FS-5000/8000 Modification of PA and COUP Boards

Addenda No. 2 to Service Manual of FS-5000 Series SM-E5519

Addenda No. 3 to Service Manual of FS-5000 Series SM-E5519

Addenda No. 4 to Service Manual of FS-5000 Series SM-E5519

Fig. 1 COUP Board

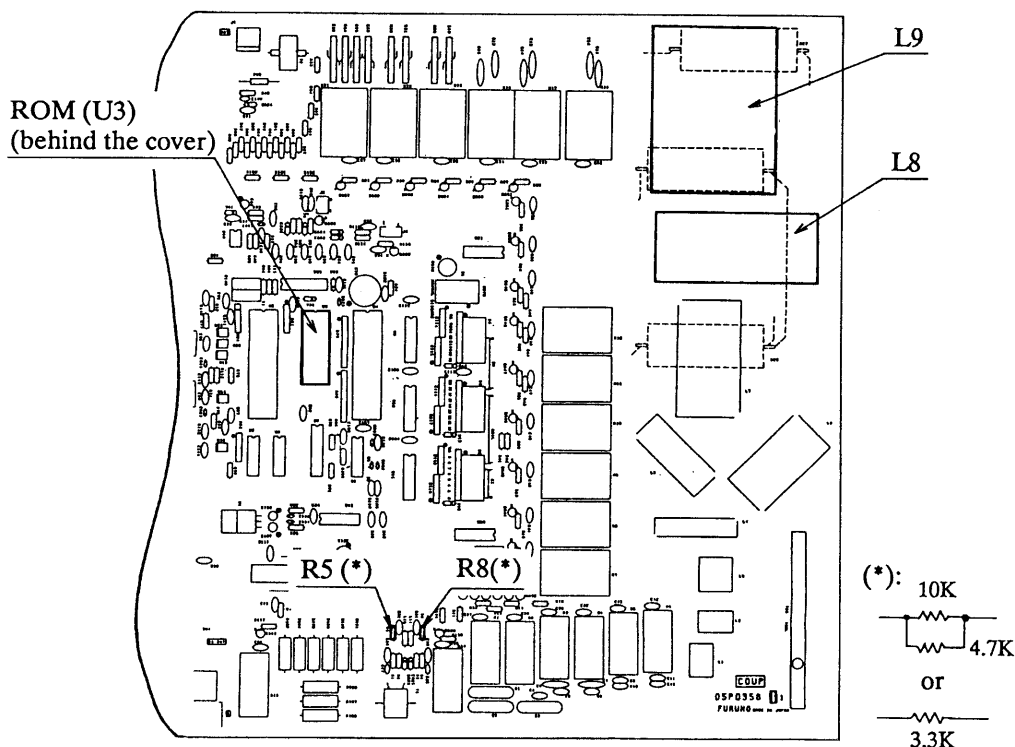
- ① **Replacement of ROM. (05501-32-101 → 05501-32-102)**
Refer to Fig. 1 for the location.
- ② **Reducing number of turns of L8 and L9 by one turn.**
(L8: 12.5T → 11.5T, L9: 19.5T → 18.5T)
See the next page.
- ③ **Change of resistance values of R5 and R8.**
(10K ohms → 3.3 K ohms)
Refer to Fig. 1 for the locations.

Reducing number of turns (L8/L9)

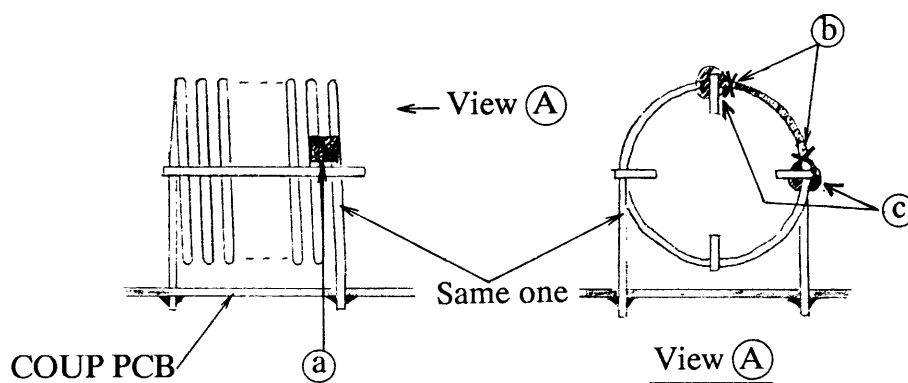
1. Solder **(a)** to shortcircuit the two cores.
2. Cut the two points **(b)** to remove 1/4 turns of a core.
3. Apply silicone sealant (supplied) to **(c)** to secure remaining cores.

Fig. 2 COUP Board

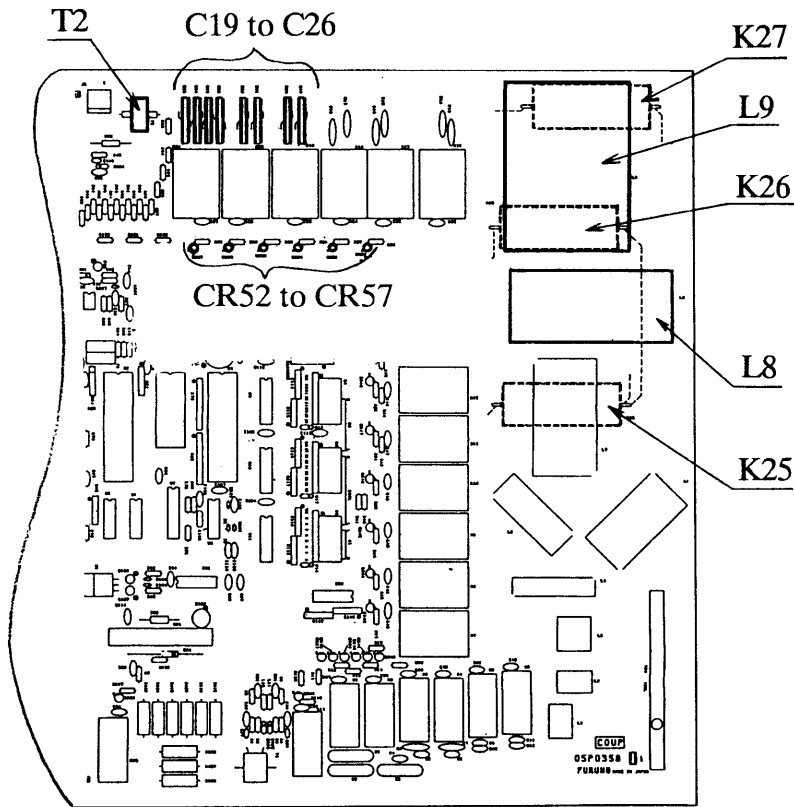
<u>Page</u>
① Clearance check of L8, L9, C19 to C26 (COUP PCB). -----	6
② Applying silicone sealant to the following parts: -----	6
[K25 to K27, T2 (COUP PCB) ----- Fig. 2]	
[K1 to K2, J1 to J2 (DUMMY LOAD PCB) ----- Fig. 3]	
③ Mounting arrester fixing metal to Antenna Coupler. -----	7
<i>NOTE: If there is a black label (●) at the bottom of the Antenna Coupler (near the earth clamp), the above modifications have been already done at factory.</i>	
④ Power reduction on 2.5 MHz or lower. -----	8
⑤ After making modifications, check for a sparking in the Antenna Coupler. -----	9

Fig. 4 Antenna Coupler

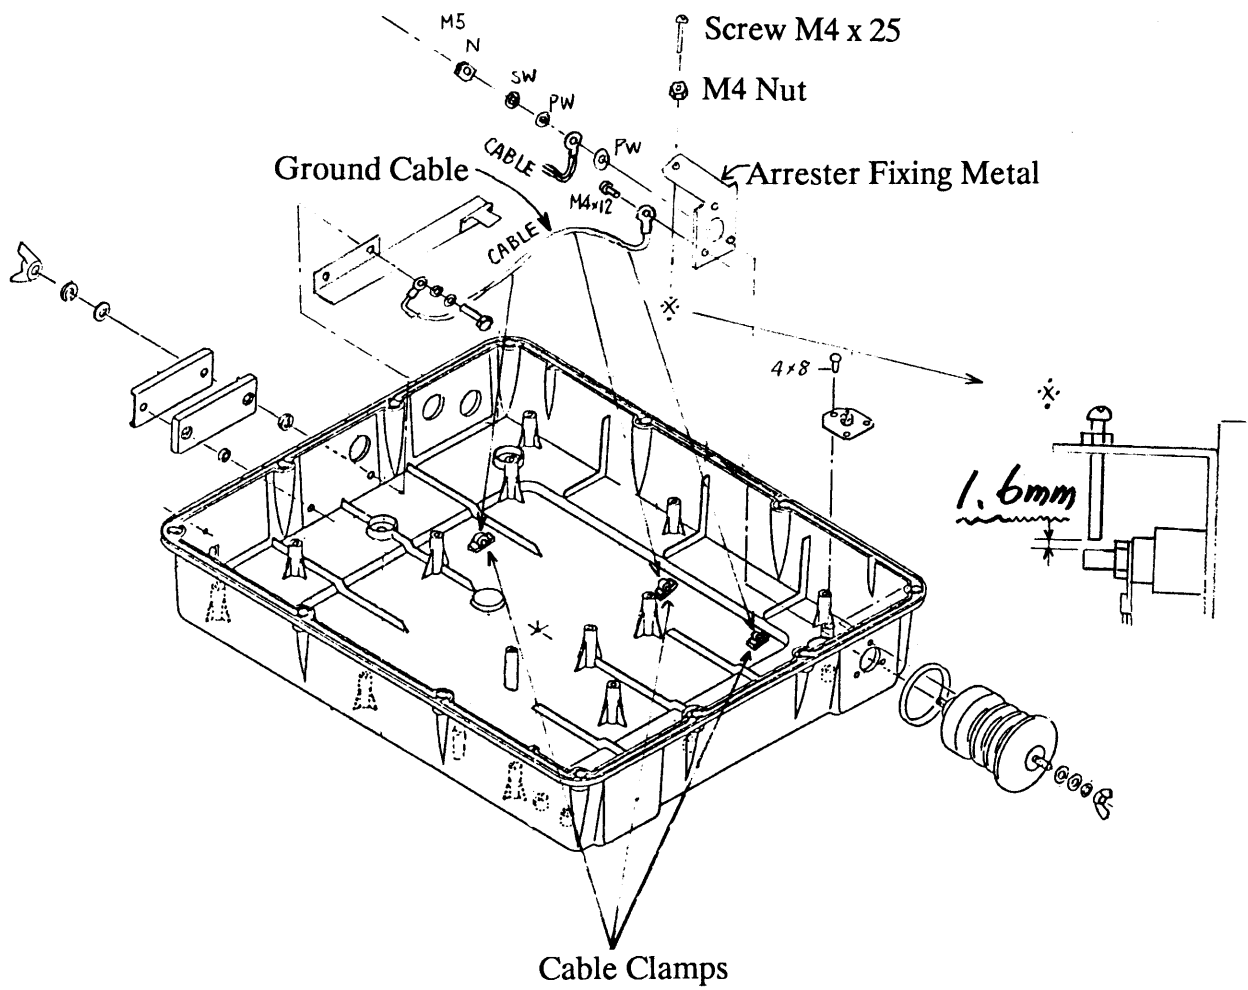
③ Mounting arrester fixing metal

Fig. 5 DUMMY LOAD Board (Parts Side)

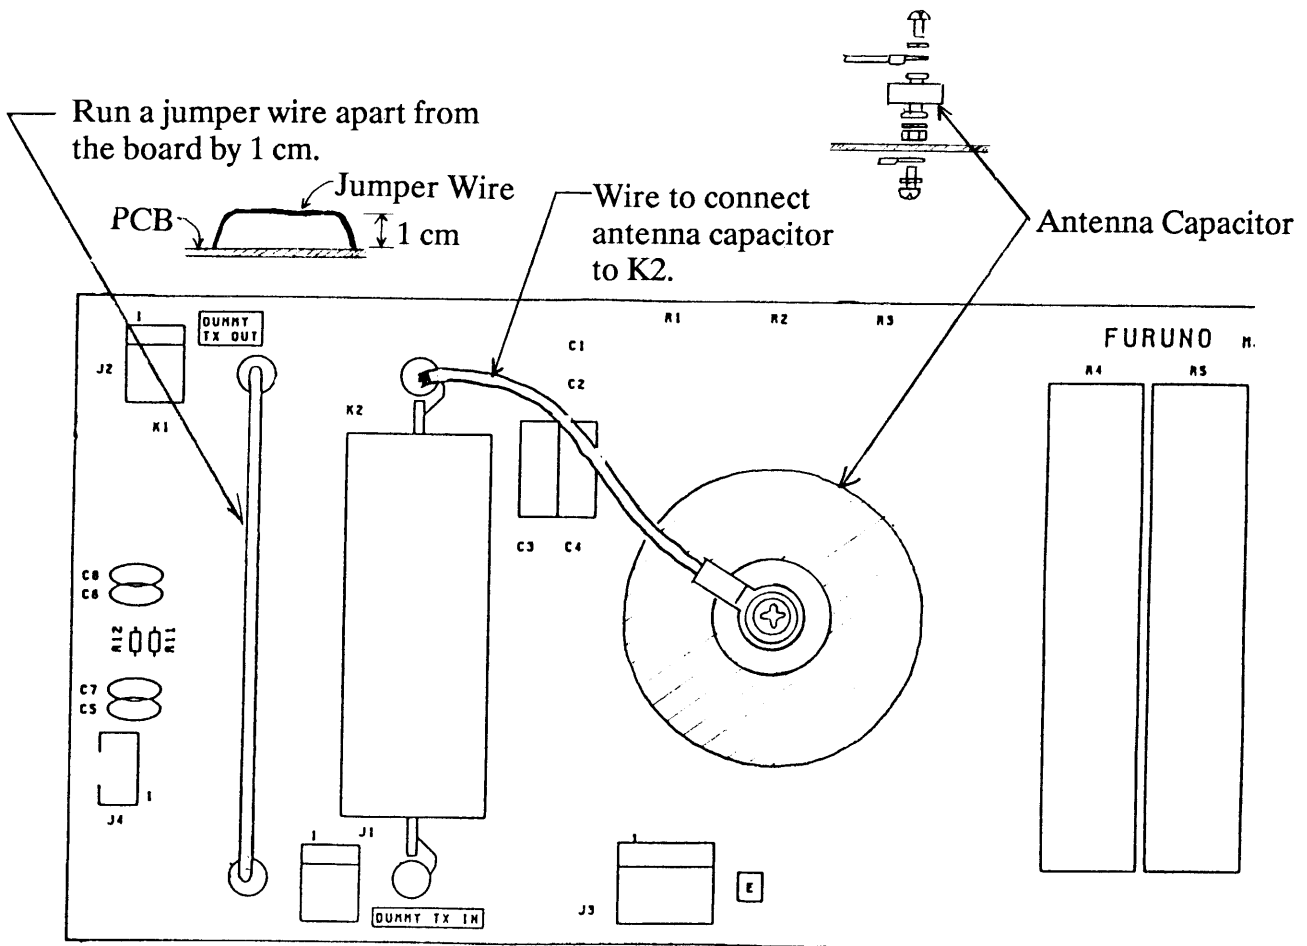
5. Referring to Fig. 5, fix antenna capacitor to board.
6. Solder a lug (supplied) to the earth pattern on the board.

Fig. 6 DUMMY LOAD Board (Soldering Side)

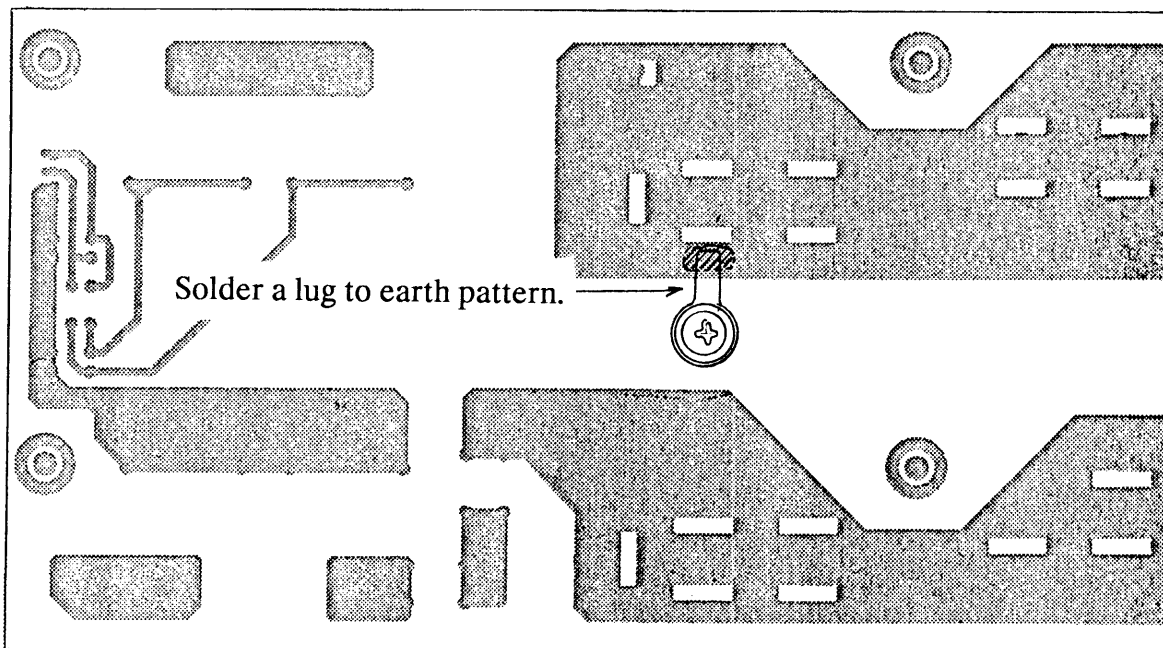
7. Apply silicone sealant (KE348T) to lead wires of J1, J2 and K2 to prevent leakage of high voltage.
8. Install the DUMMY LOAD board to the Antenna Coupler.
9. Be sure wiring does not contact other wirings and parts.

Double-mounted transformer

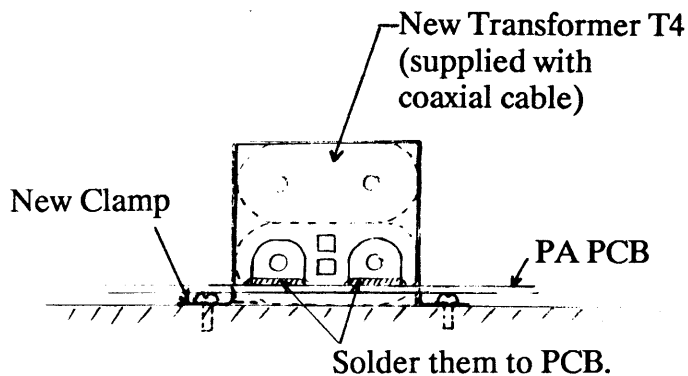
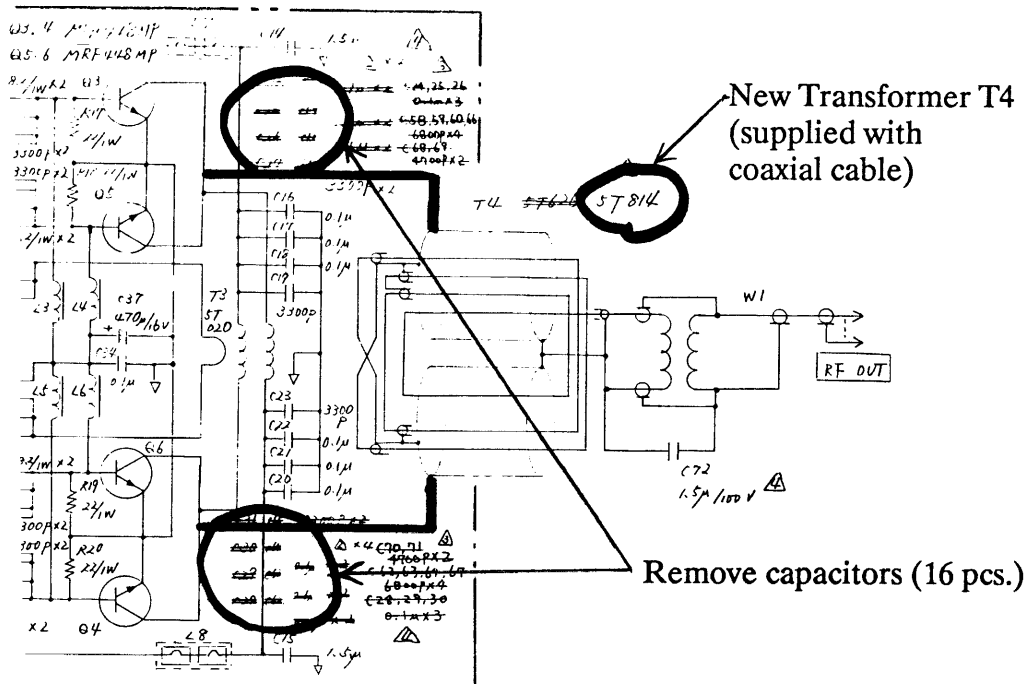
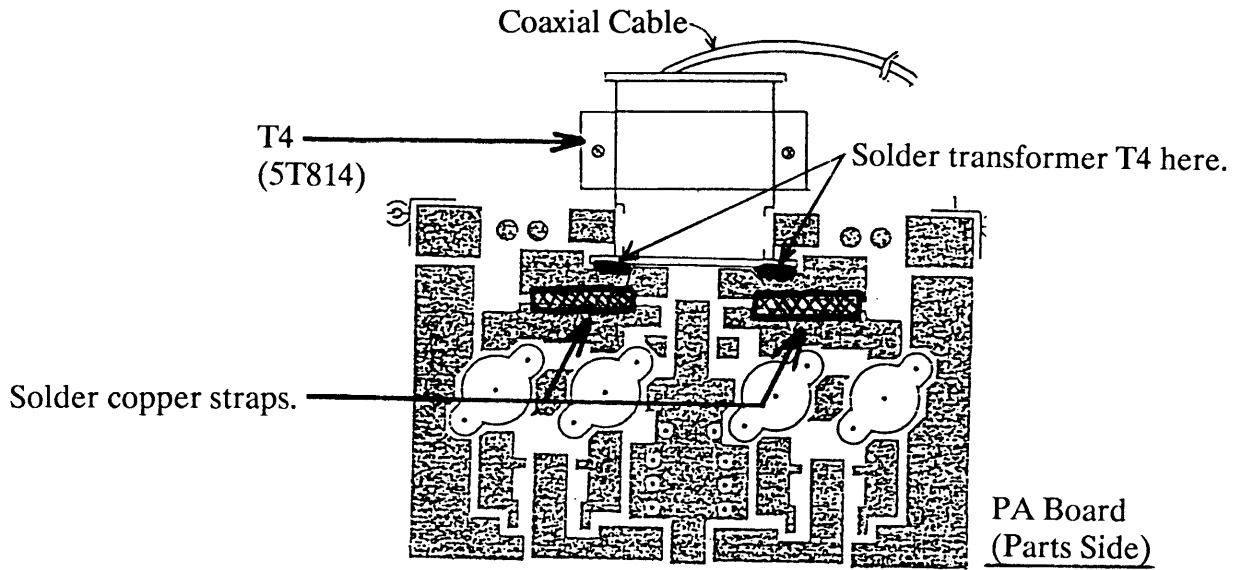
- ① Replacement of transformer T4 (5T626 → 5T814)

- ② Removal of capacitors (16 pcs.) in hatched portions and soldering copper straps there.

Photo No.1086

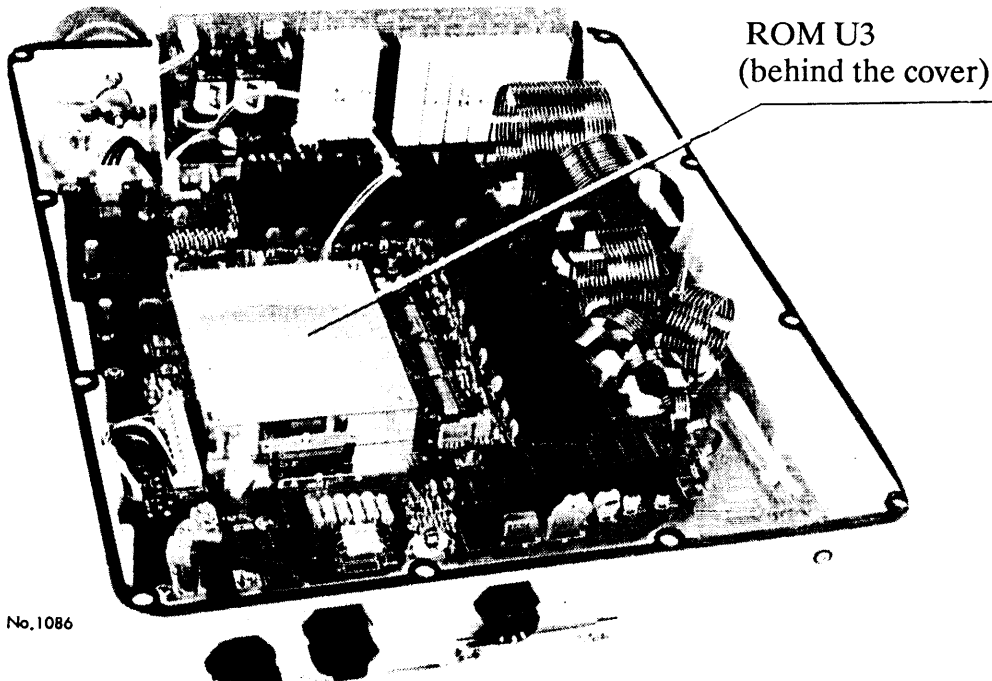
The program of the ROM U3 on the COUP board in the Antenna Coupler has been changed, from version no. 2 to 3.

Automatic tuning sequence has been changed to allow use of the pi-network on 1.6 to 3.4 MHz, because these frequencies cannot be tuned on some long wire antenna installations.

AF board (Soldering side)

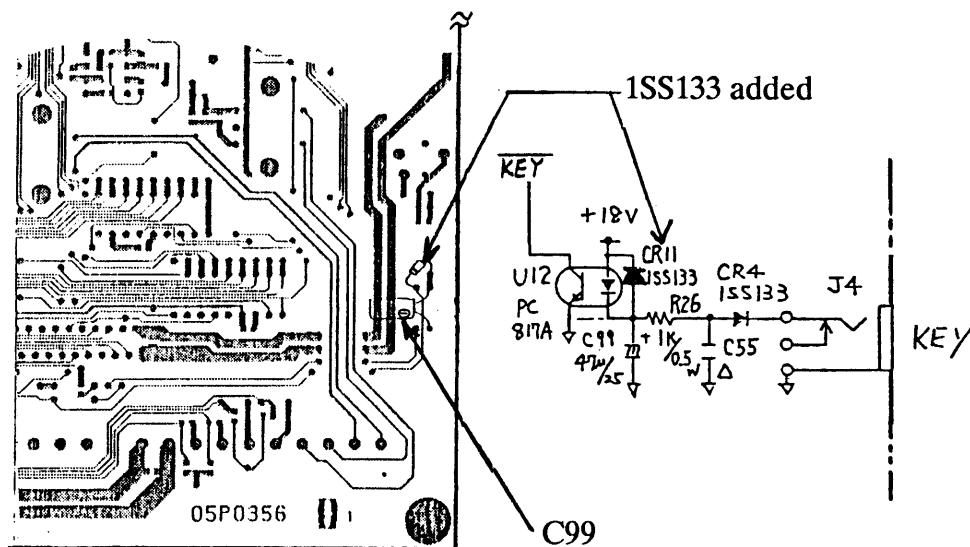
C55 Charging voltage : 18V
 U12 Reverse voltage (max.) : $V_R = 6V$

- Remedy : Replace U12 with a new one and add diode 1SS133 (code no. : 000-103-097) in parallel with U12 as shown in the figure below.

J4 on
COUP PCB

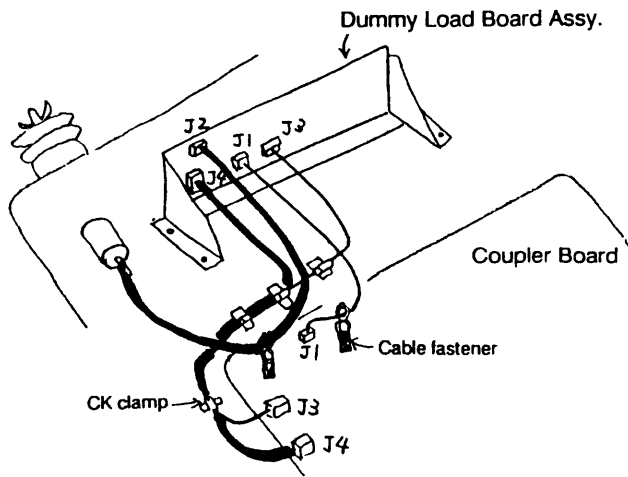
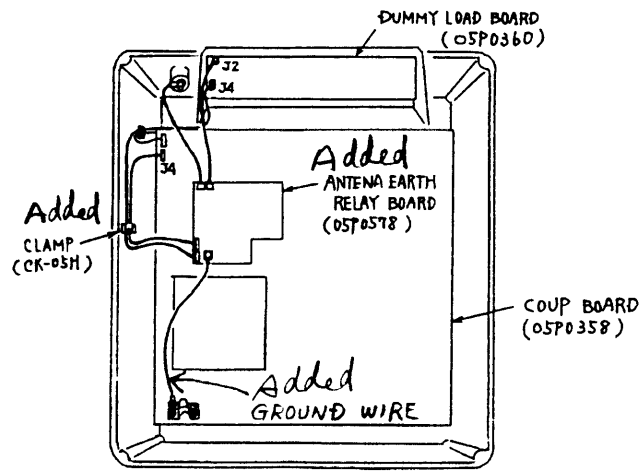
2. Change wire connections as shown below.

Fig.1

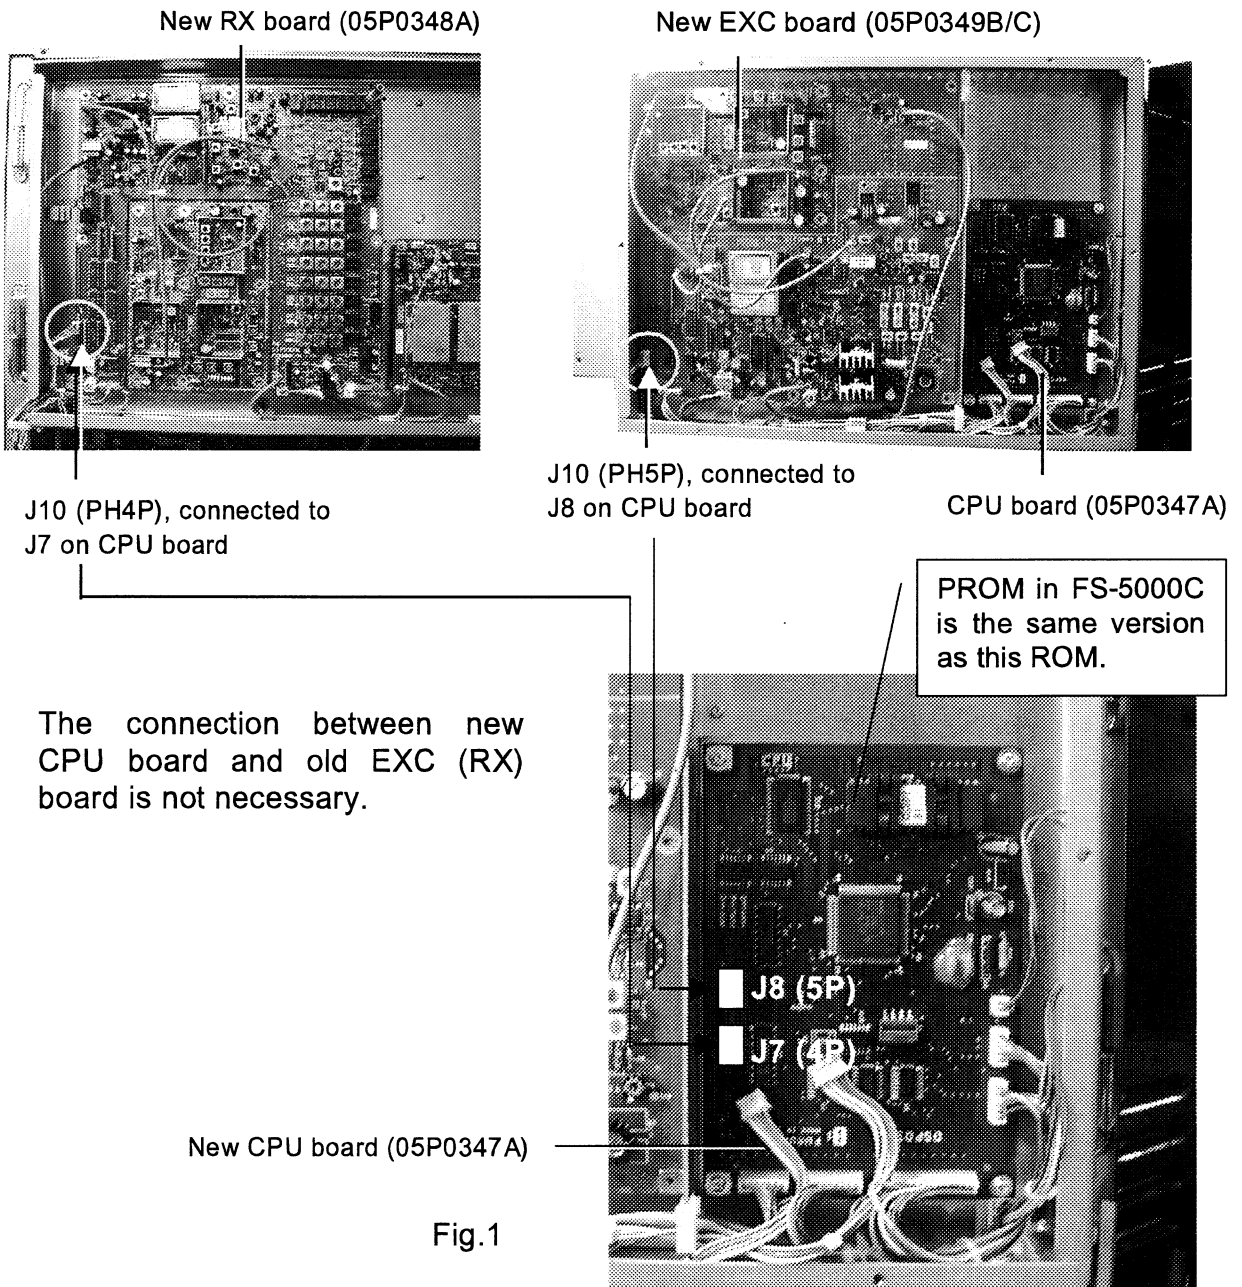
Three printed circuit boards, CPU, EXC, and RX are modified because the production of PLL IC, M54927P is discontinued. New CPU board recognizes EXC and RX board type, so new CPU board is used with old EXC and/or RX board without modification.

1. Change CPU board to new one.
2. Change PROM in FS-5000C to Ver. 0550131124.
3. Change EXC and/or RX board with new one.
4. Connect new CPU board with new EXC (RX) board.

Fig. 2 "p.c.b type" signal lines on EXC and RX boards

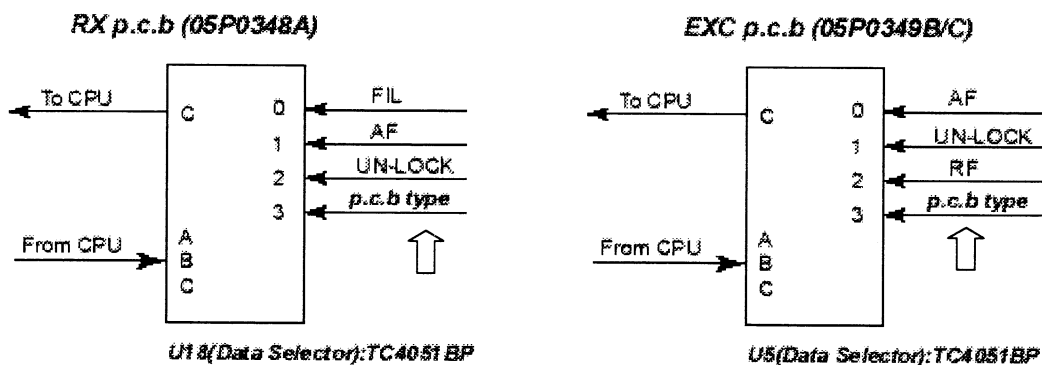
Board type signal, or "p.c.b type" signal is connected to EXC and RX boards as shown in Fig. 2. The CPU sets the signal to both L and H levels and if the CPU detects the set level, the board is new.
